Title: Advisory Committee on Reactor Safeguards
ESBWR Subcommittee: OPEN SESSION

Date: Tuesday, October 20, 2009

ESBWR DCD

PCCS Condenser with
support structure

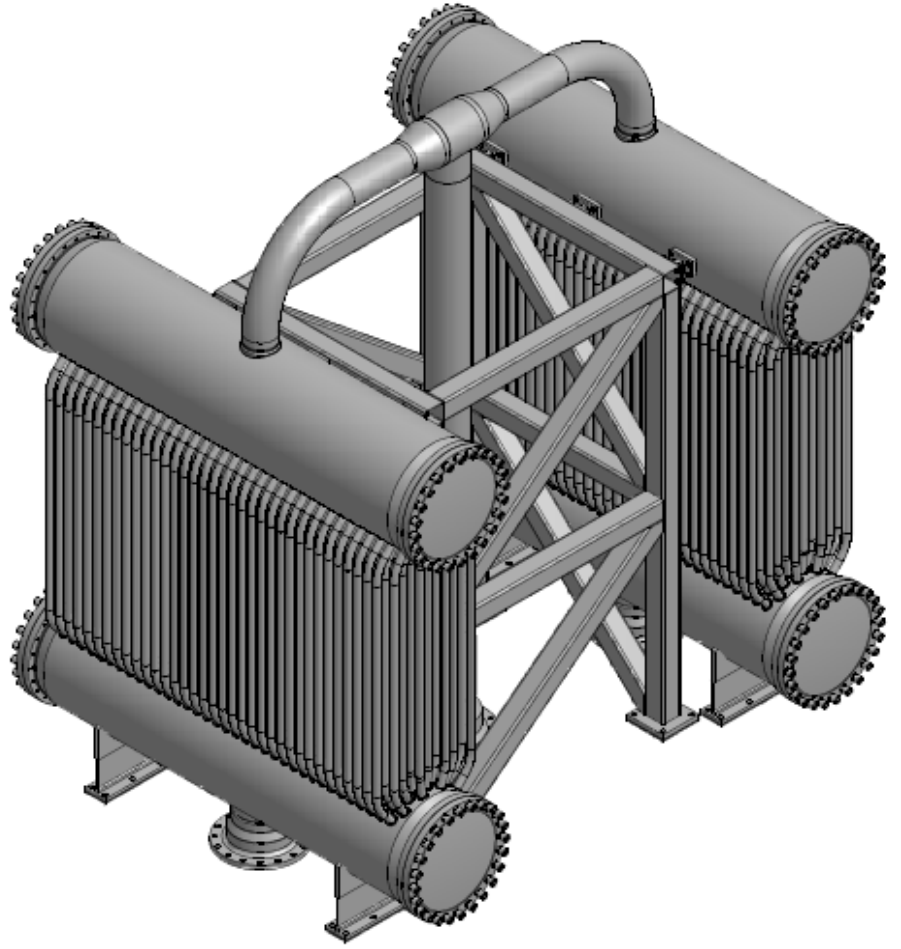
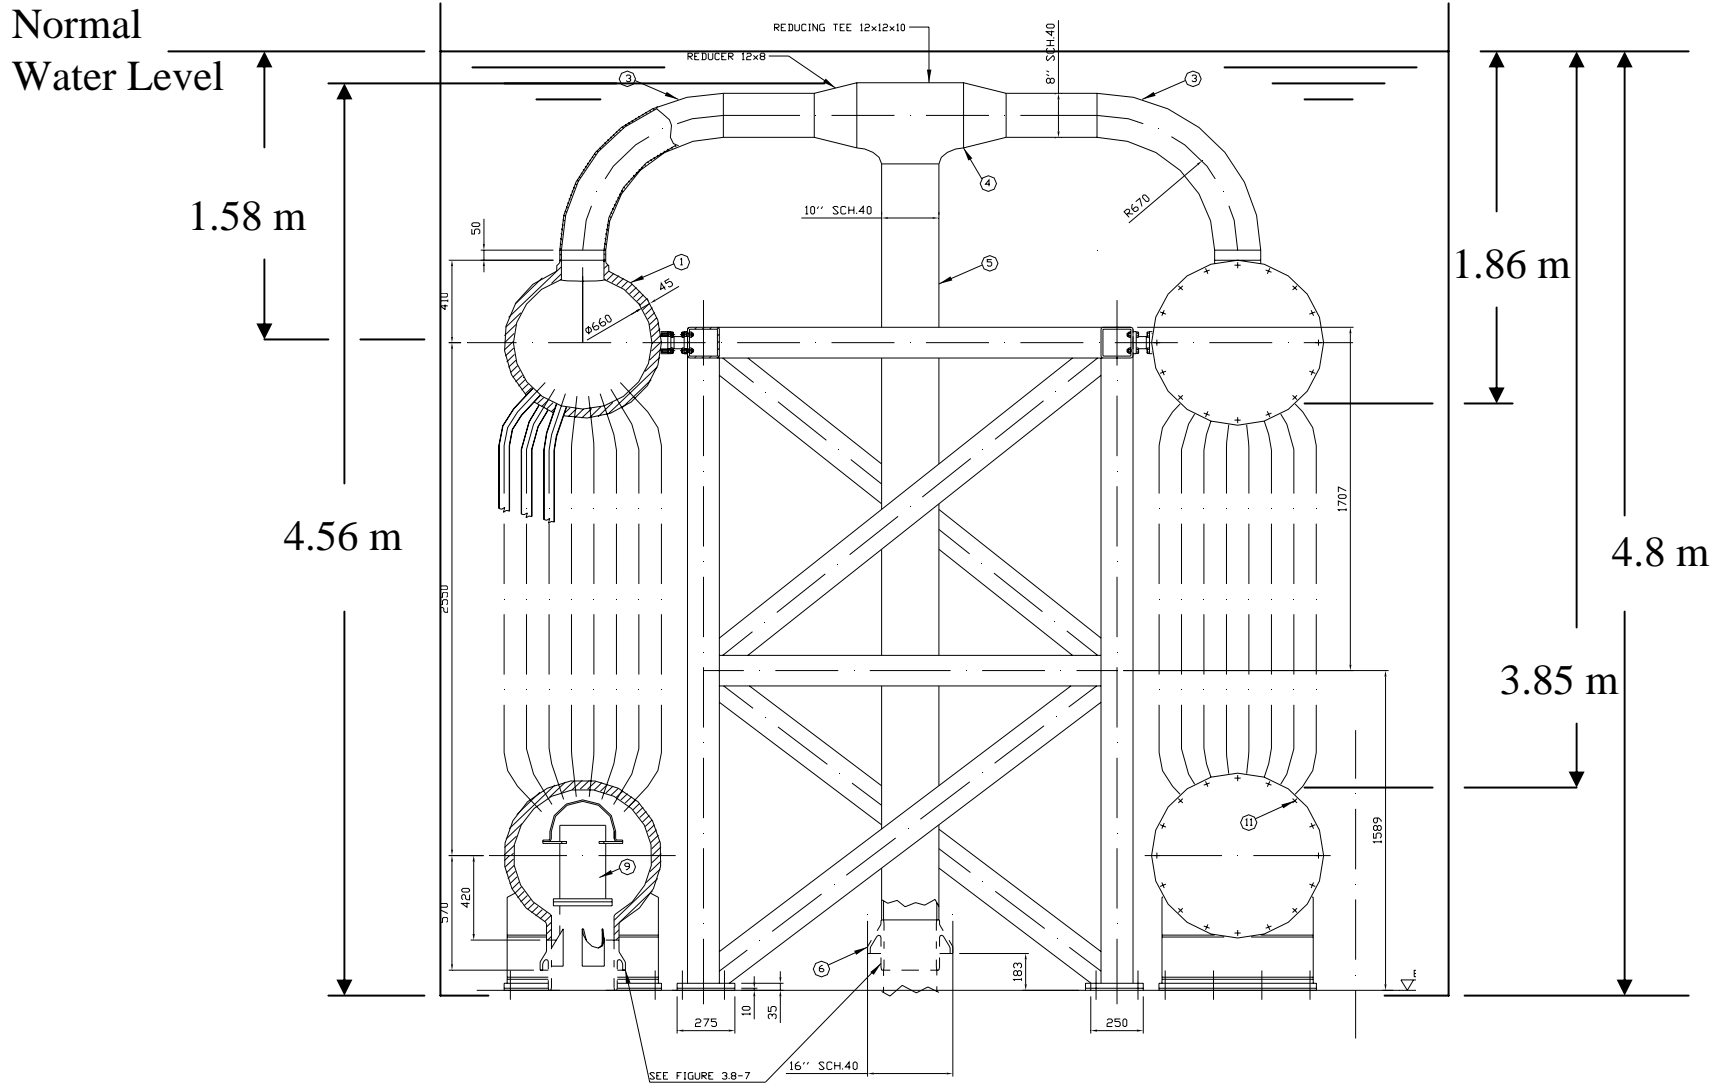
17 CHAIRMAN CORRADINI: Just one question now
18 about support. So is the support design for the PCCS
19 and the ICS identical and you show one with and one
20 without just for illustration purposes?

22 CONSULTANT WALLIS: So this branch from
23 the upper header to the wall is correct in the drawing
24 before this one?

1 CONSULTANT WALLIS: The distance from the
2 wall is correct?

21 CONSULTANT WALLIS: Well that is what you
22 say but until I see a drawing that is accurate, I
23 don't really know.

7 MR. DEEVER: The pool width is five meters
8 and the PCCS is about four meters, as I remember. So
9 there is some clearance to the wall. Part of that
10 clearance is actually shown in this figure.

Isolation Condenser Schematic

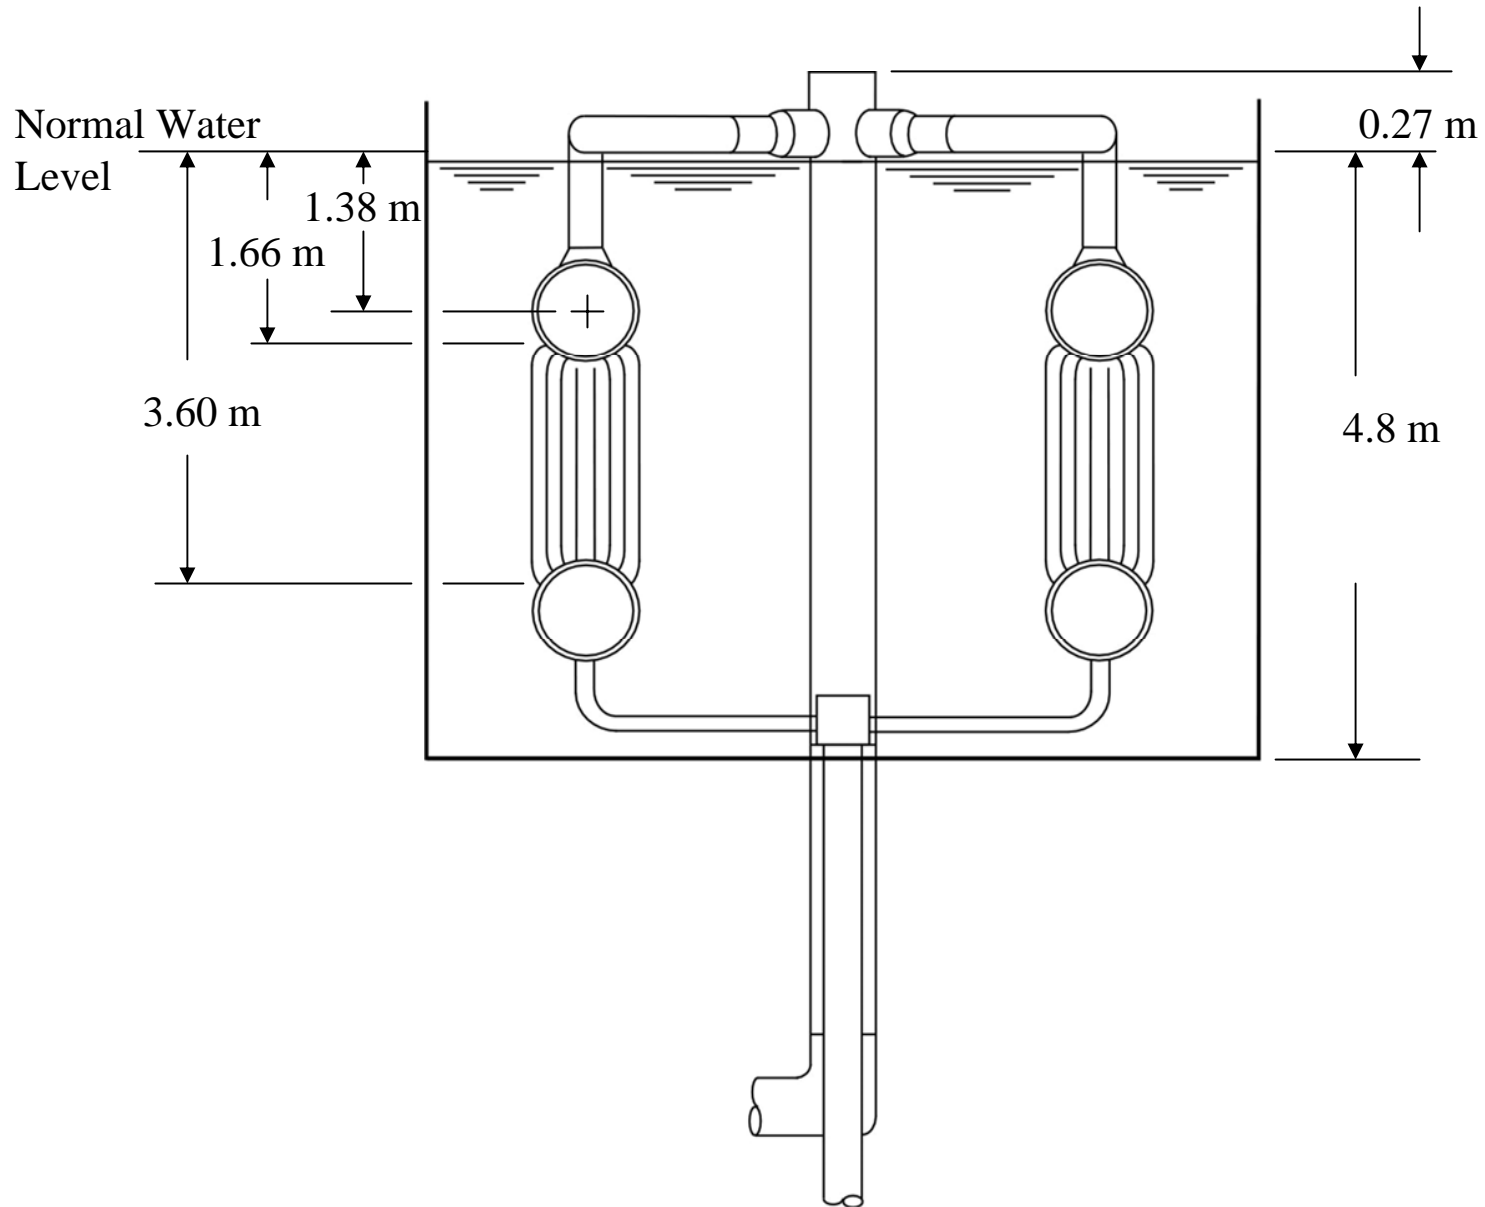
16 CONSULTANT WALLIS: Will you show where
17 the gas is collected in the isolation condenser?

3 CONSULTANT WALLIS: -- and then seven. Is
4 that the way it goes? The drawing says four.

13 CONSULTANT WALLIS: Do you have a drawing
14 of the ICS like the PCCS which is more detailed that
15 we could look at?

16 This one here, the one in the previous
17 slide you show more detail than you do in this. And I
18 grant that schematics often depict the skeletons. So
19 I would like to see the real scale of the ICS with
20 details.

Stress Analysis of Pool Structures

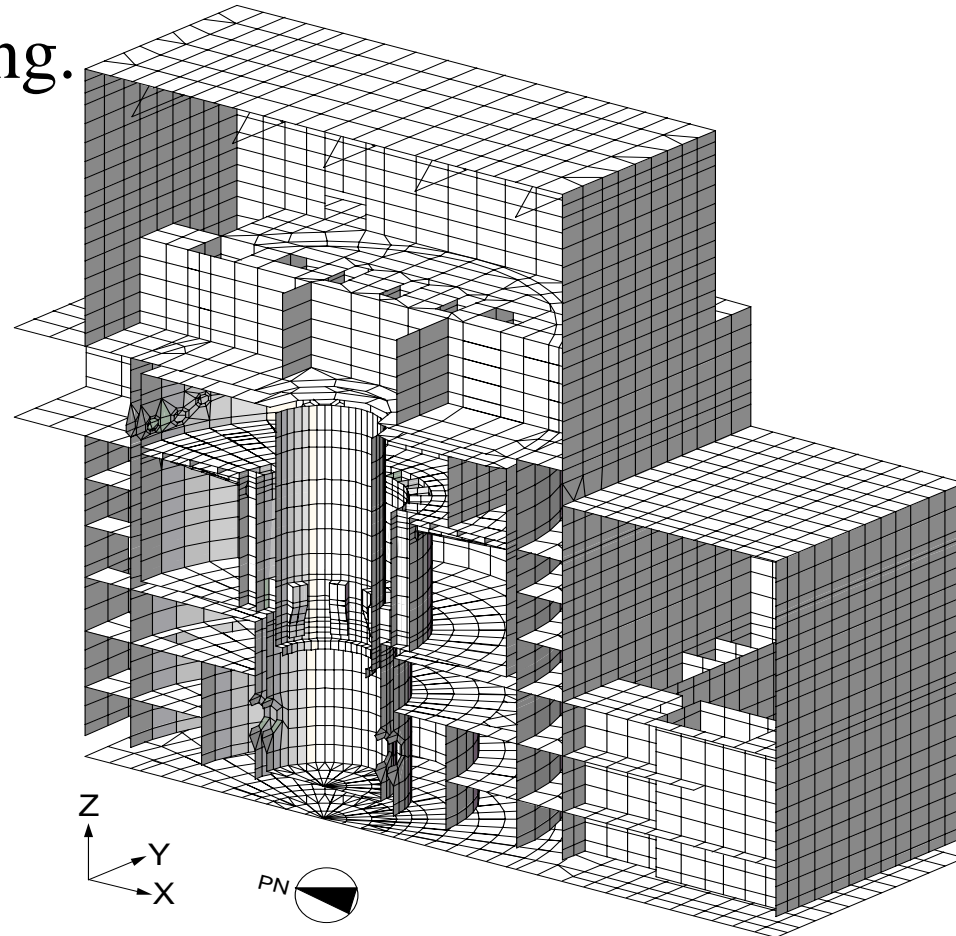
17 MEMBER ABDEL-KHALIK: On the previous
18 figure, is this the actual modelization they use in
19 the finite element analysis?

17 MEMBER ABDEL-KHALIK: Well my concern is
18 about the resolution of the mesh. I mean, this seems
19 like a very course mesh. And the question is whether
20 or not you actually checked whether the resolution of
21 the mesh is adequate.

2 MR. JENG: As to the question how do you
3 know how refined should be adequate? I think the
4 program is nearly built yet we check the convergence.

5 Okay? If they want to try and see that they converge
6 in a solution. If they don't converge, that means we
7 have to move on so we cut the size to half inch and
8 adjust until such a time your response is stable.
9 That defines how refined this mortar should be. It is
10 a basic technique available in that code technology.
